August 3, 2018

Re: Site C Project – Proposed Design Changes to the Halfway River Bridge Design

Table 1. EIS Halfway River Bridge Design Compared to Proposed Design Changes

Figure 3: General arrangement of Highway 29 realignment segment at Halfway River, per proposed modified design (Proposed Figure 4.32 Rev 2)

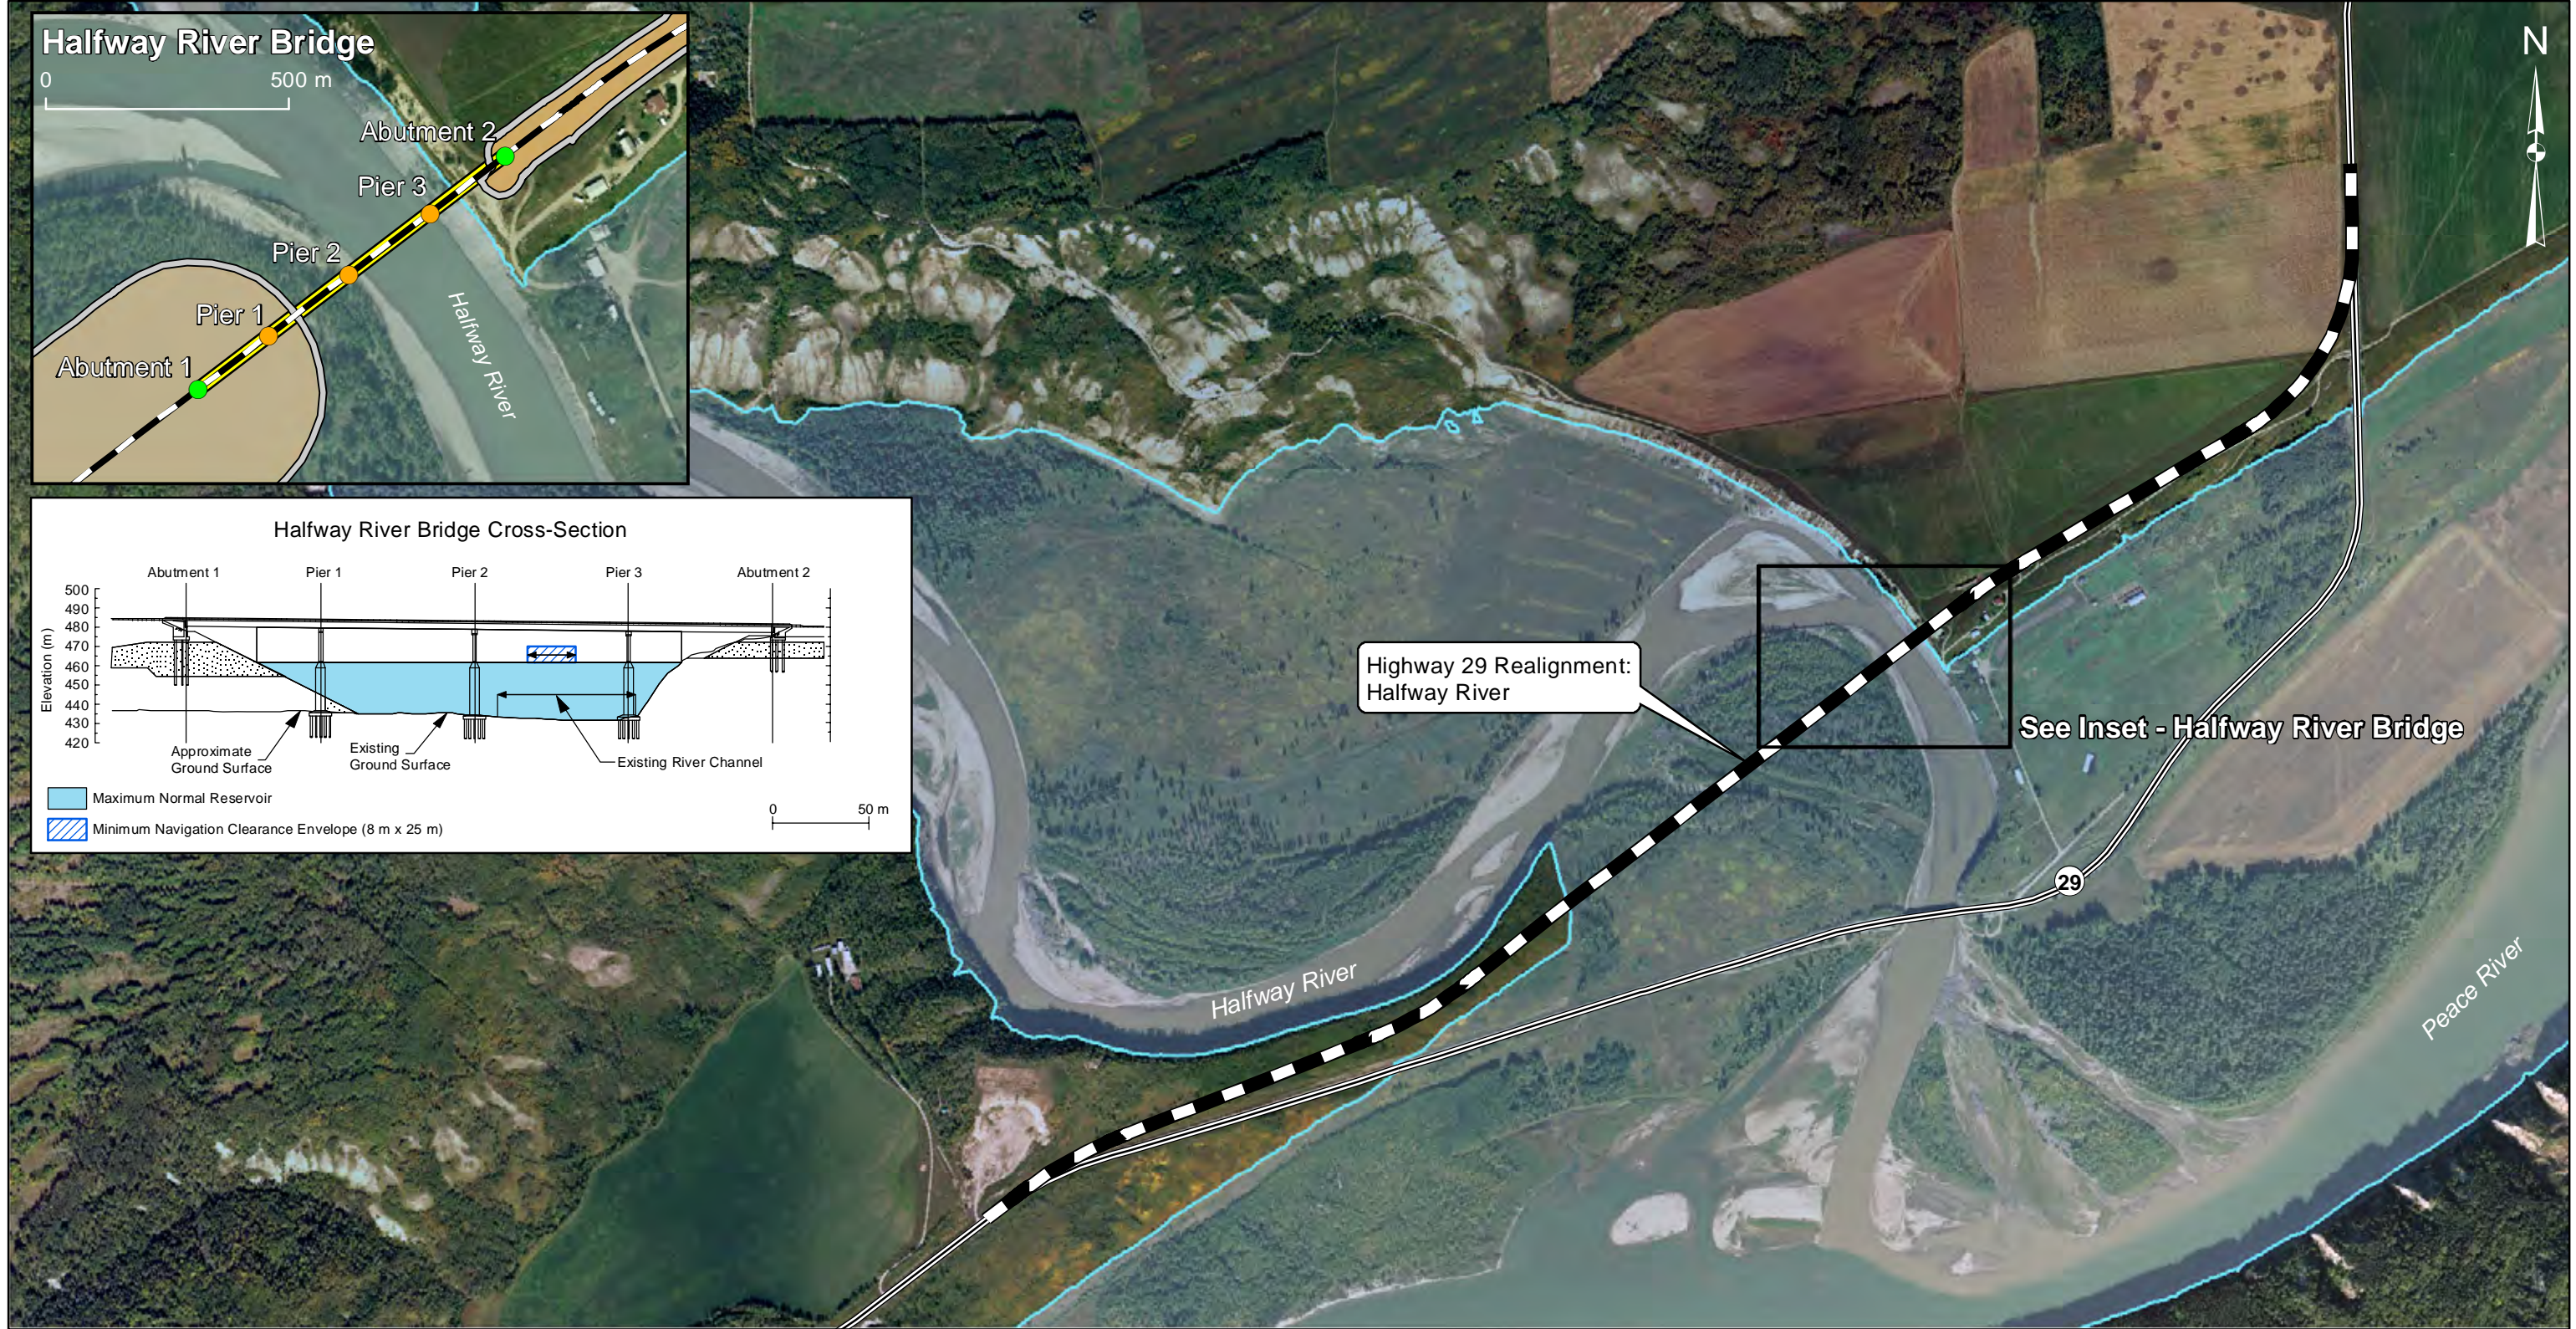
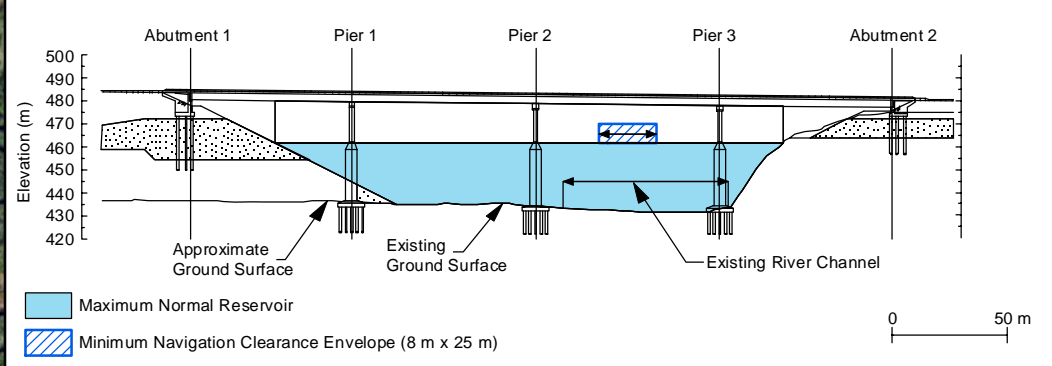
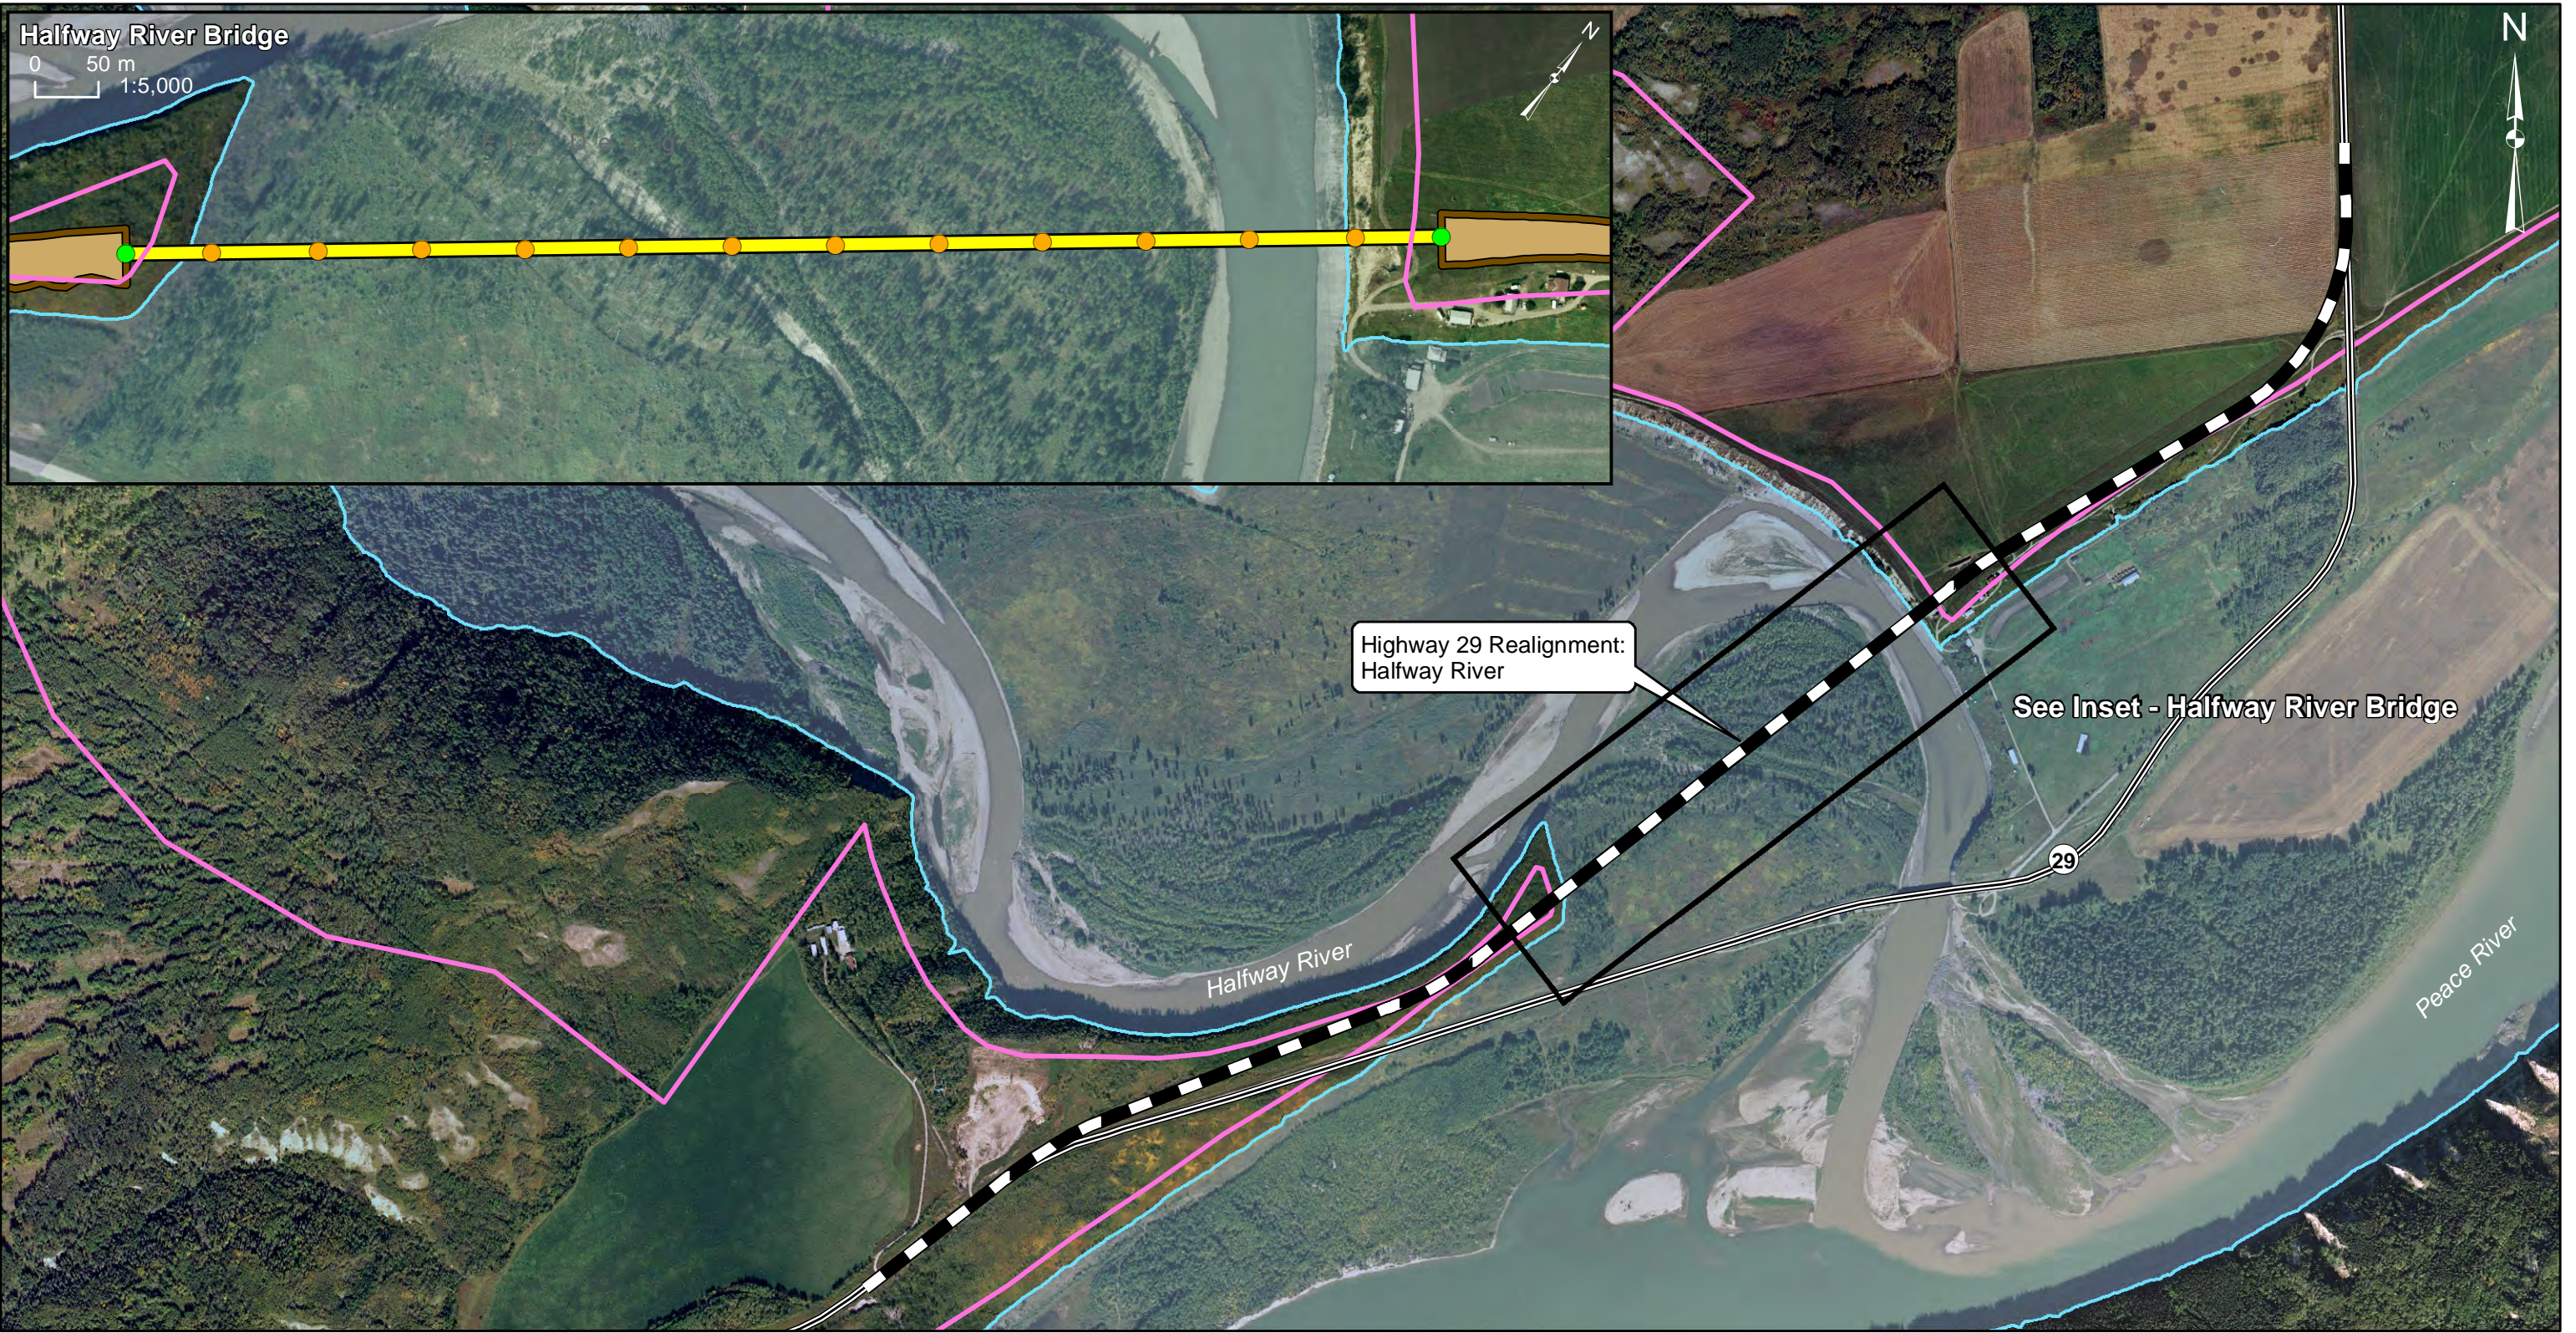
Component	Statement Text from EIS	Revision to EIS Text
Highway 29 Realignment	Section 4.3.4.1, Table 4.5: Highway 29 Realignment Segments and Respective Watercourse Crossing Lengths For Halfway River: Total Length of Segment: 4.0 km Causeway Length: 640 m Bridge Length: 305 m Number of Piers: 3 Number of Bridge Spans: 4 Figure Number 4.32 Rev 0	Section 4.3.4.1, Table 4.5: Highway 29 Realignment Segments and Respective Watercourse Crossing Lengths For Halfway River:* Total Length of Segment: 3.7 km Causeway Length: 0 m Bridge Length: 1,042 m Number of Piers: 12 Number of Bridge Spans: 13 Figure Number 4.32 Rev 2

All figures are provided in Appendix A. Figure 2 shows the general arrangement of the Halfway River Bridge, per EIS Section 4 (Figure 4.32, Rev. 0). Figure 3 shows the general arrangement of the proposed modified Halfway River Bridge (Figure 4.32, Rev 2). Figures 4 and 5 show the bridge profiles of the EIS design and the proposed modified design respectively.

Figure 6: Halfway River Bridge - EIS Design versus Modified Design

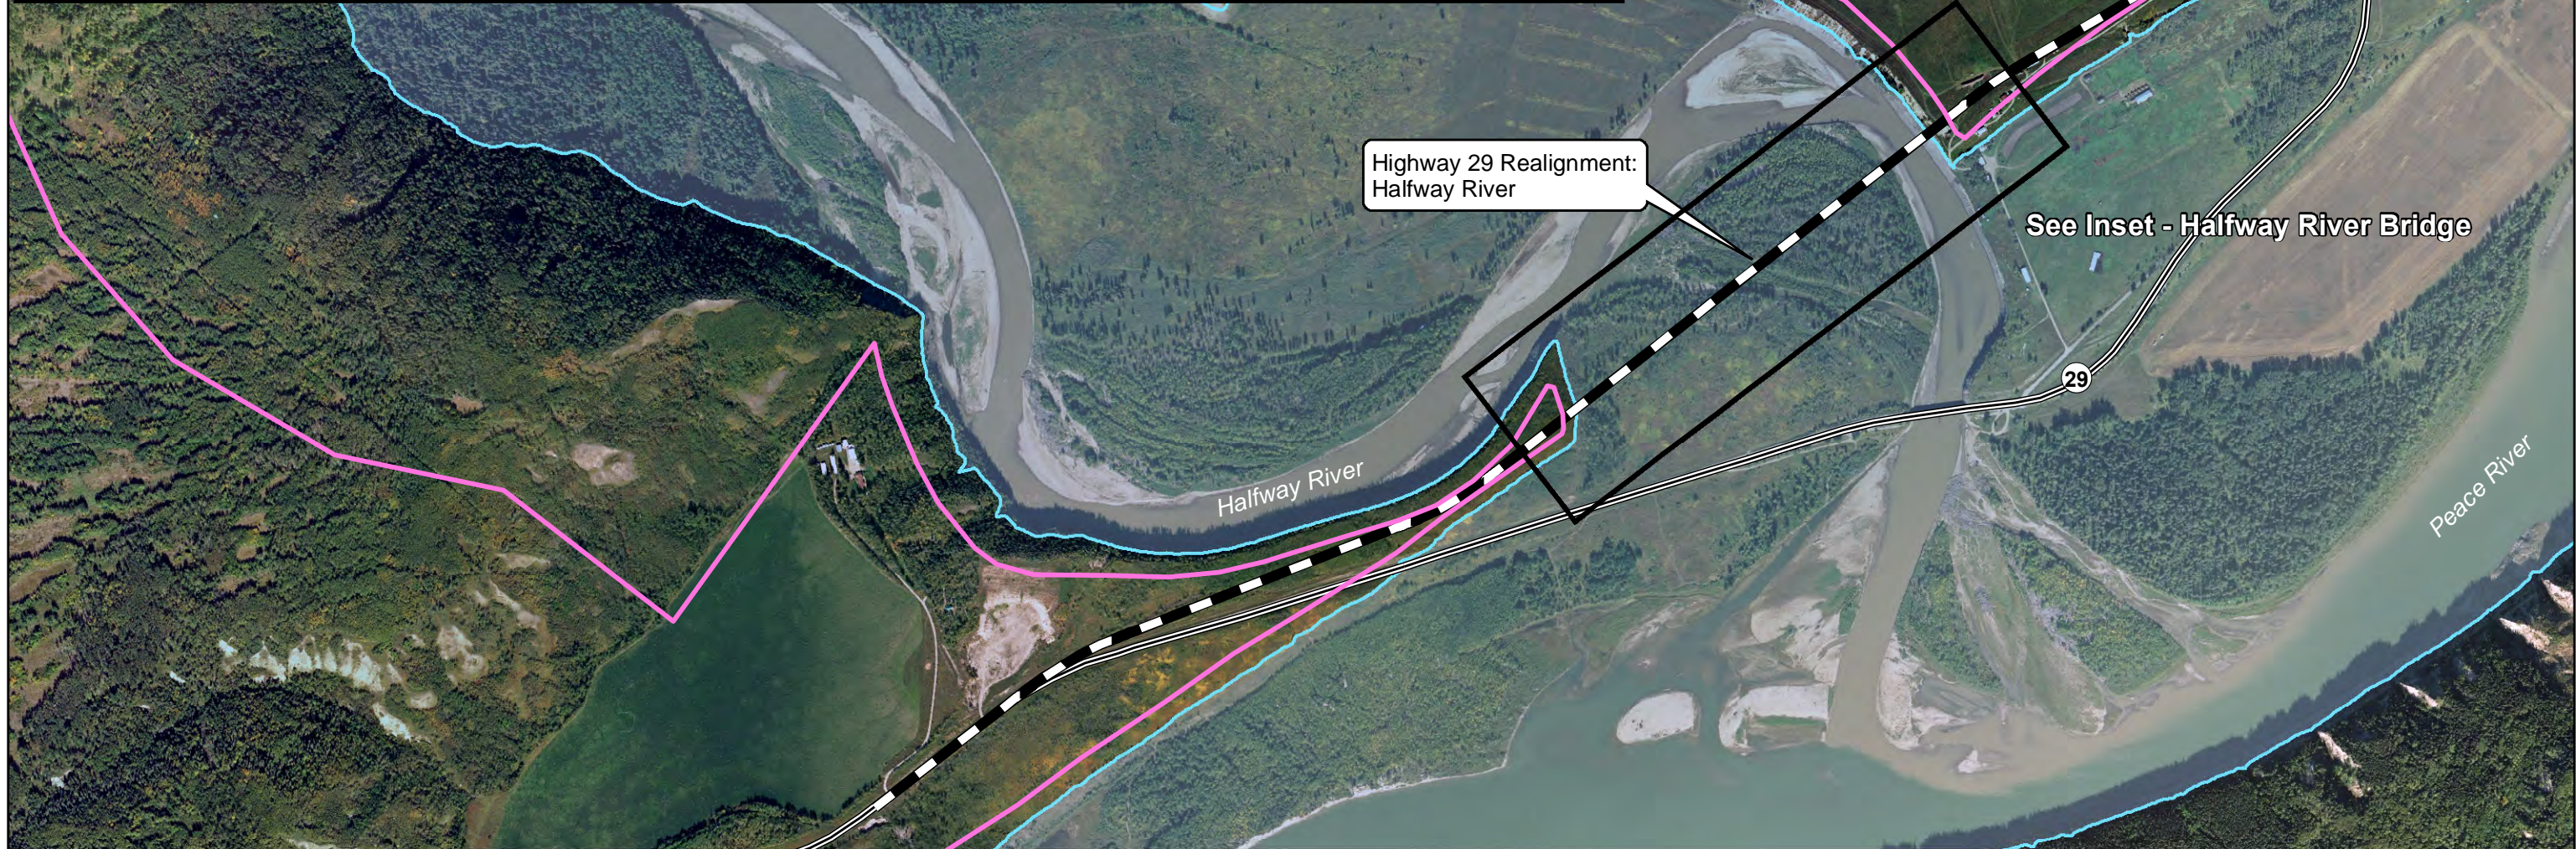
The proposed modification to the Halfway River Bridge design is not expected to cause any additional effects on fish and fish habitat beyond those predicted in the EIS. As shown in Figures 6 and 7, the 640 m causeway per the EIS design will be replaced by piers in the proposed modified design, resulting in a smaller overall riparian and terrestrial footprint of the Halfway River crossing.

The proposed modification to the Halfway River Bridge design is not expected to cause any additional effects on vegetation and ecological communities or wildlife resources beyond those predicted in the EIS. As shown in Figures 6 and 7, the 640 m causeway per the EIS design will be replaced by piers in the proposed modified design, resulting in a smaller overall riparian and terrestrial footprint of the Halfway River crossing. Therefore, no additional impact on sensitive ecological communities or wildlife habitat is anticipated beyond what has been assessed in the EIS.
